RS-15-097

Nine Mile Point Nuclear Station, Unit 1
Renewed Facility Operating License No. DPR-63
NRC Docket No. 50-220

Subject: Report of Full Compliance with March 12, 2012 Commission Order Modifying Licenses with Regard to Reliable Spent Fuel Pool Instrumentation (Order Number EA-12-051)

ISE RAI No. 2 – Figure 3

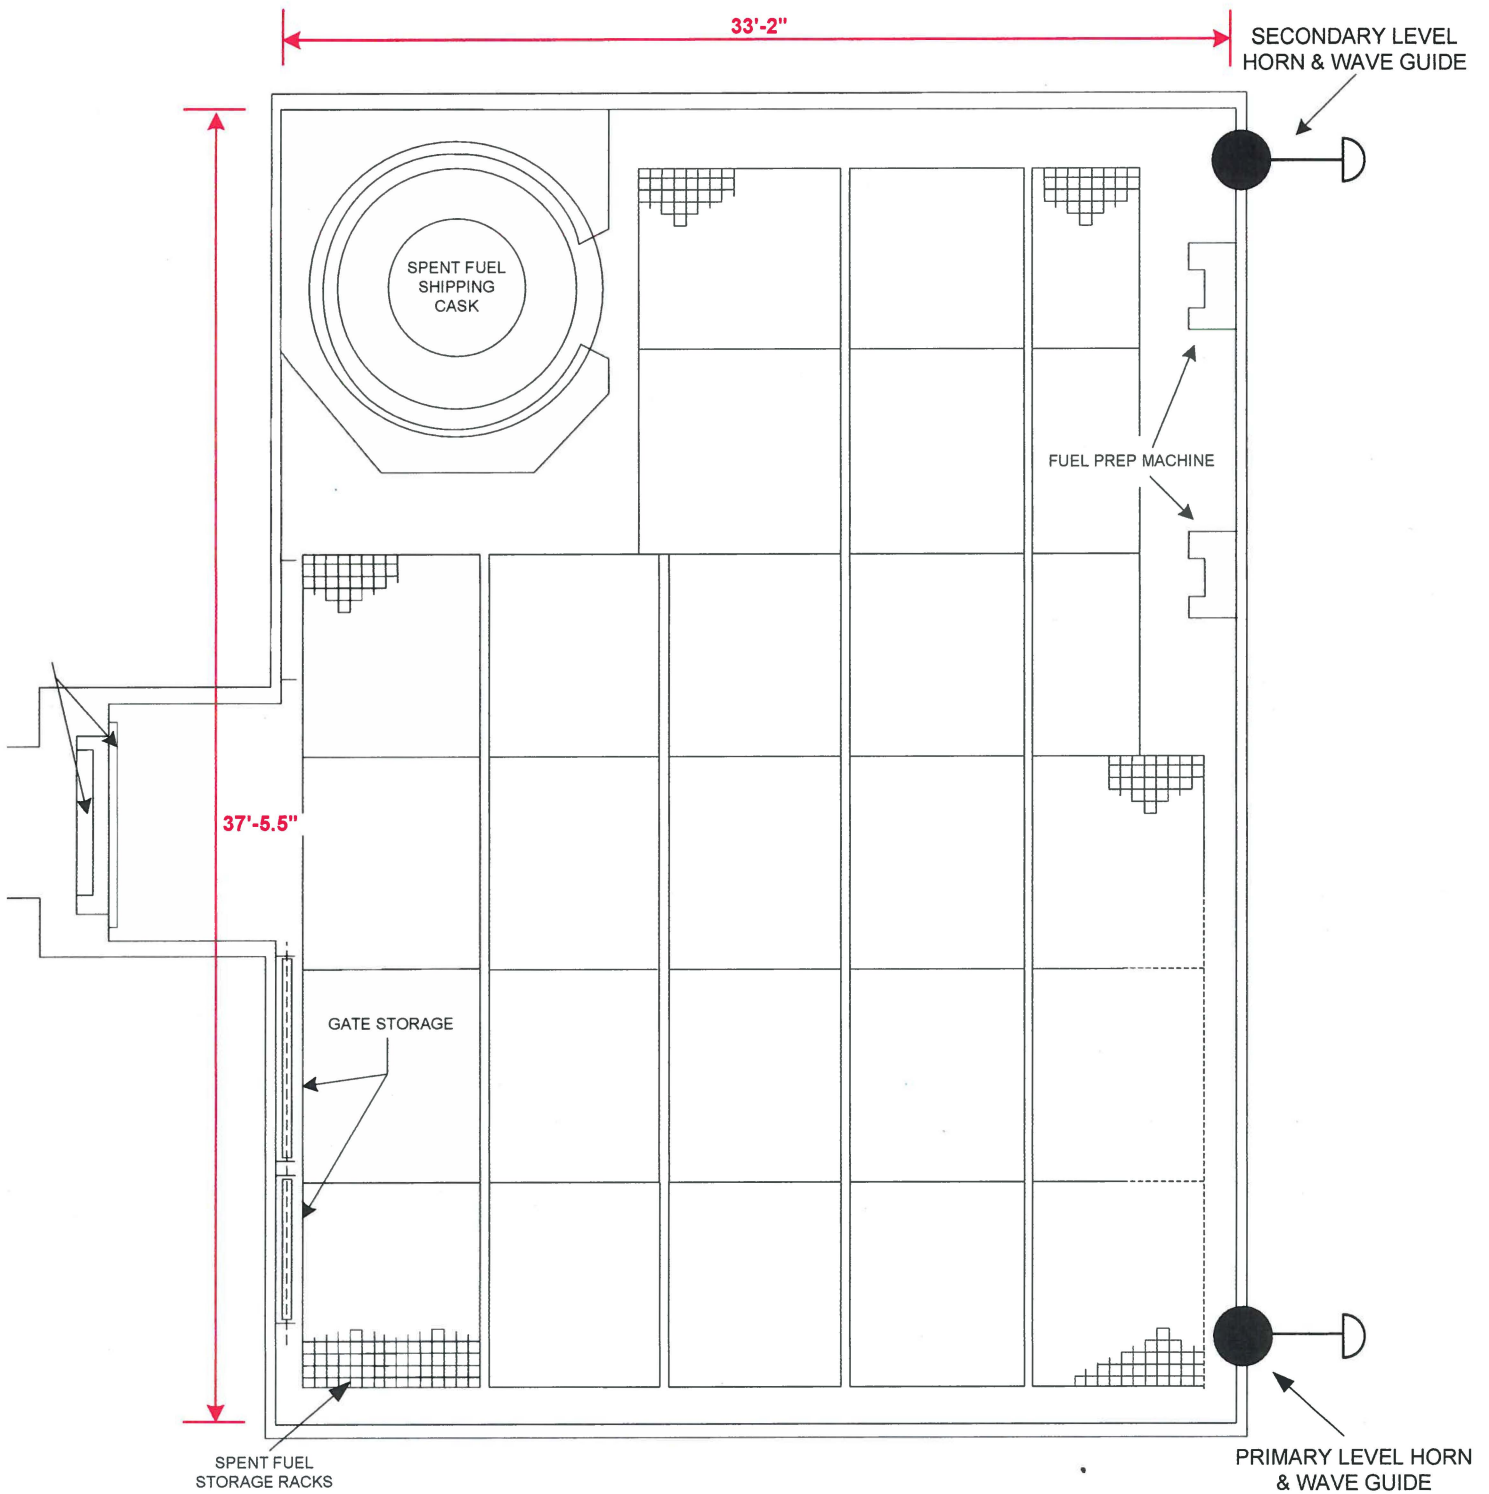
Item	Description	Reference
ISE RAI No. 2 – Provide a final labeled sketch or marked-up plant drawing of the plan view of the SFP, depicting the SFP inside dimensions, the planned locations/placement of the primary and back-up SFP level sensor, and the proposed routing of the cables that will extend from these sensors toward the location of the read-out/display device.	Refer to enclosed drawings (Figures 1-4) for the SFP and associated SFP Level Sensors and waveguide tubing route. The NMP1 Spent Fuel Pool is 33'-2" wide by 37'-5.5" long and 39'-2" deep. The primary level sensor will be mounted on the east side of the southeast corner of the spent fuel pool on elevation 340' in the Reactor Building. The back-up sensor (redundant) will be mounted on the east side of the north east corner of the spent fuel pool on elevation 340' in the Reactor Building. Both Primary	Complete

<p>and Backup sensor tubing will proceed east for a short distance before each enter a new core bore through the refuel floor concrete slab. The sensor tubing will travel further east and vertically downward where the sensor electronics are mounted on the east wall of the Reactor Building (north and south for the respective level sensor) on the elevation 318' one level below the Refueling Floor. Local level indication is provided next to the sensor electronics at this location. From this point, the instrument cables are routed in separate dedicated conduit within the Reactor Building down to elevation 261' and 250'. From there the cables are routed in separate cable tray through the Turbine Building and into the Auxiliary Control Room for primary and backup SFP level readout capability. The Auxiliary Control Room is located one elevation below and is accessible from the Main Control Room.</p>
